NOTICE OF APPROVAL

Planning Case #: Design Review 22258

Project Description: Plantings, irrigation, and low-level landscape lighting at 5th Avenue 2 NW of San Carlos in the Service-Commercial (SC) District as depicted in the plans prepared by RANA Landscape Architecture, stamped approved on September 1, 2022 and on file at the Community Planning & Building Department, unless modified by the conditions of approval. This approval also authorizes a slightly revised trellis design (previously approved under DR 22-170) three trellis-mounted heaters.

PROJECT TITLE
CHEZ NOIR
5TH AVENUE
CARMEL, CALIFORNIA

A830

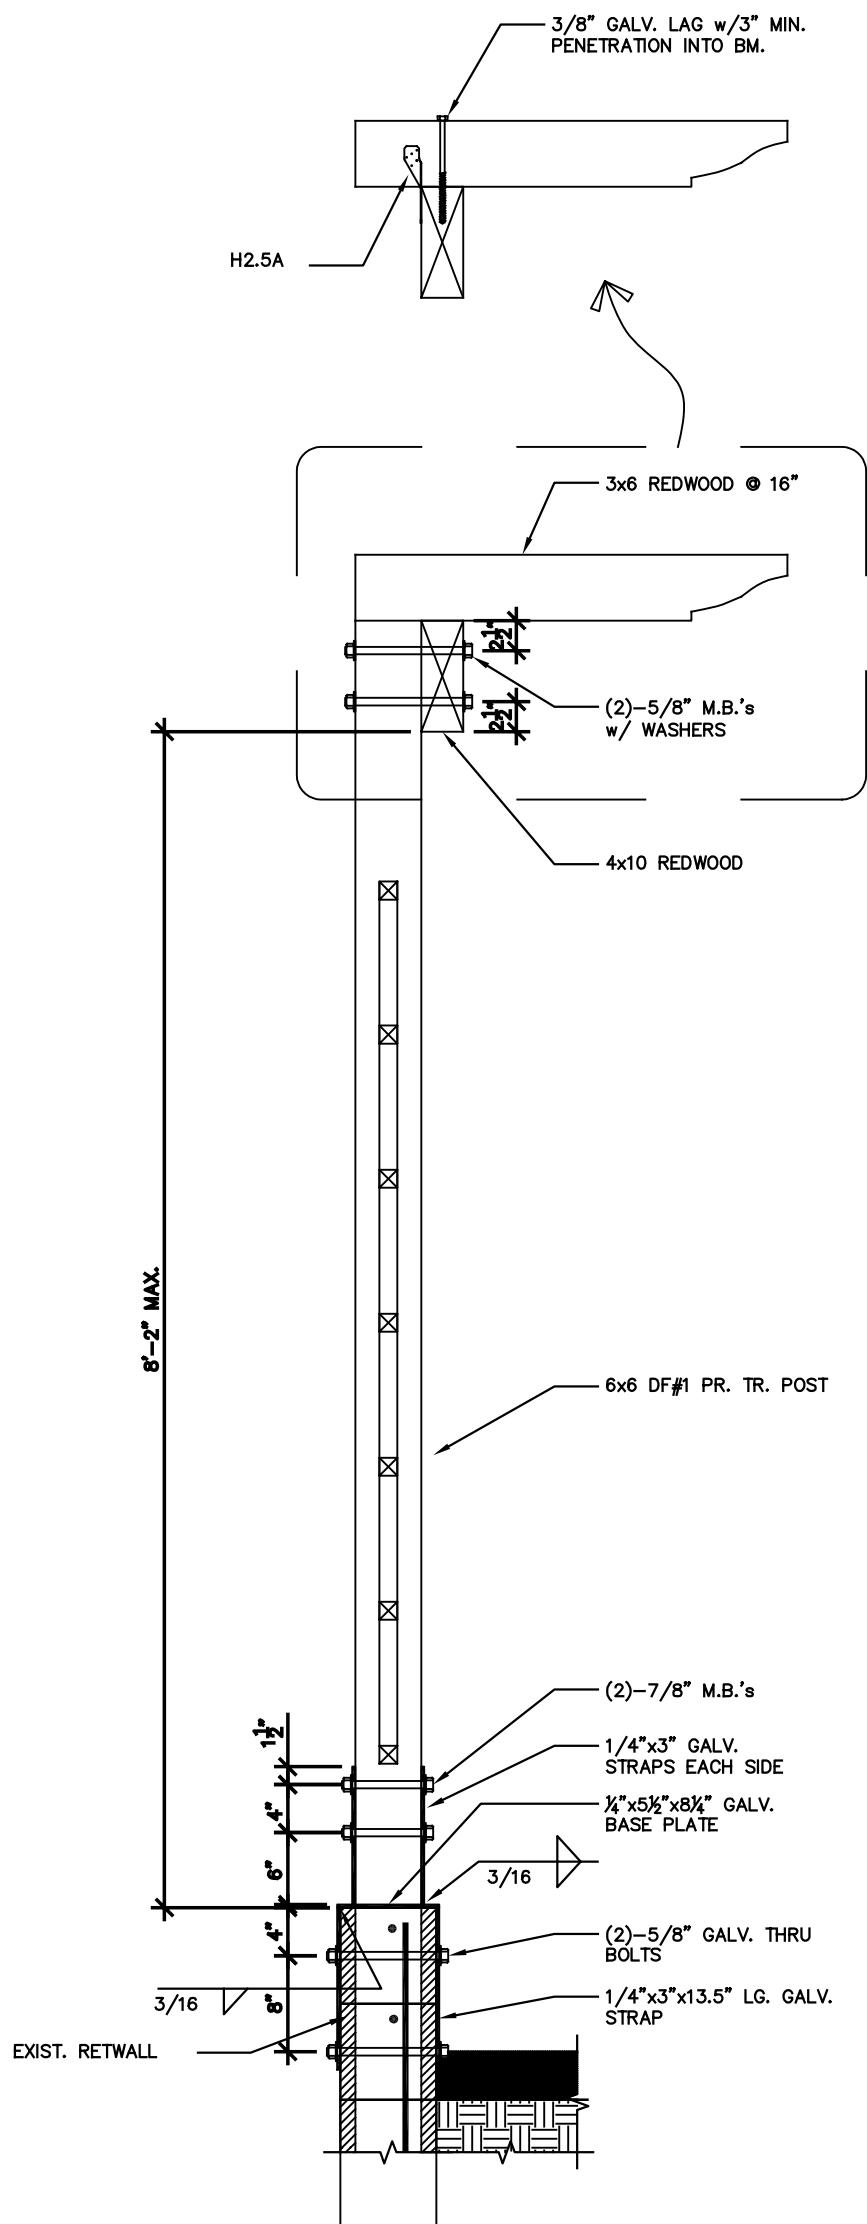
12.	<p>Heaters. Prior to the issuance of a building permit, the applicant shall submit a dimensioned elevation detail depicting the heater installation on the trellis. The mounted heaters shall be shielded from view from the public right-of-way OR shall be designed to be architecturally compatible with the village character and adjacent building, per CMC 17.14.220.D.</p>	✓

13.	<p>Lighting. This approval does not authorize the installation of lighting on or attached to the trellis.</p>	✓
14.	<p>Tree. Prior to final inspection, the applicant shall select and install one of the following trees for the tree well in the public right-of-way: catalpa; cultivated aesculus (not californica); linden; hackberry; zelkova; dogwood; pistache; cork oak; elm; honeylocust; coffee tree- male; or ginkgo- male.</p>	✓
